Access Compliance Report

Public Rights-of-Way (Curb Ramps)

Intersection ID: 29134	Main Street: BALSAM_TREE_DR	Cross Street: CREEK_BREEZE_RD	Location: SE
ADA ID: CEC11C9B3E6E	Ramp Type: BlendTrans1	Initial Pass/Fail: Fail	Overall Compliance: No
		Severity Score: 25

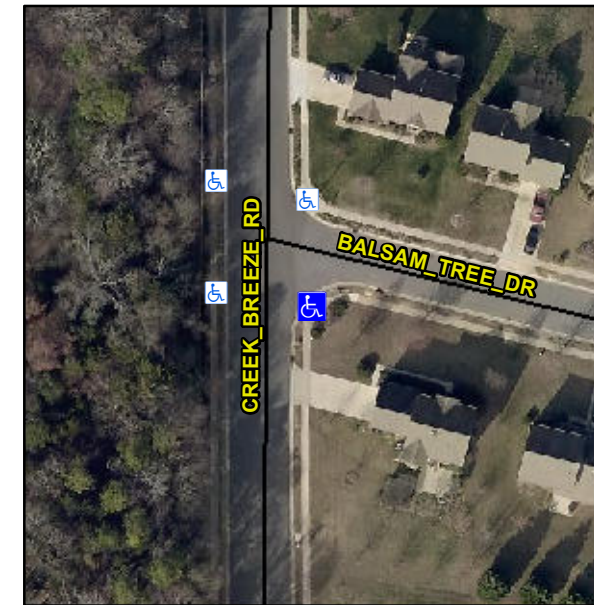
Not Found, R304.5.3

Compliance	Description	Data	Compliance	Description	Data
N/A	Ramp Length (in)	42.0	Yes	BlendTrans Slope (%)	2.7
Yes	Ramp Width (in)	64.0	No	BlendTrans XSlope (%)	7.6
N/A	Flare Type LT	N/A	N/A	Flare Type RT	N/A
N/A	Flare Slope LT (%)	N/A	N/A	Flare Slope RT (%)	N/A
N/A	Flare Traversable LT?	N/A	N/A	Flare Traversable RT?	N/A
N/A	Landing Length (in)	N/A	N/A	DWS Provided?	N/A
N/A	Landing Width (in)	N/A	N/A	DWS Contrast?	N/A
N/A	Landing Slope (%)	N/A	N/A	DWS Length (in)	N/A
N/A	Landing X Slope (%)	N/A	N/A	DWS Full Width?	N/A
N/A	Landing Curb? (Y/N)	N/A	N/A	DWS Offset (in)	N/A
N/A	Shared Landing?	N/A			
N/A	Gutter Ponding?	N/A	N/A	Gutter Slope (%)	N/A
N/A	Gutter Lip Ht (in)	N/A	N/A	Gutter X Slope (%)	N/A
N/A	Painted X Walk1?	No	N/A	Painted X Walk2?	No
	X Walk 1 Direction	To N		X Walk 2 Direction	To W
	X Walk 1 Width (in)	N/A		X Walk 2 Width (in)	N/A
	X Walk 1 Slope (%)	5.9		X Walk 2 Slope (%)	4.5
	X Walk 1 X Slope (%)	1.5		X Walk 2 X Slope (%)	7.8

Remove & Replace Curb Ramp With Two New Directional Ramps or Equivalent.
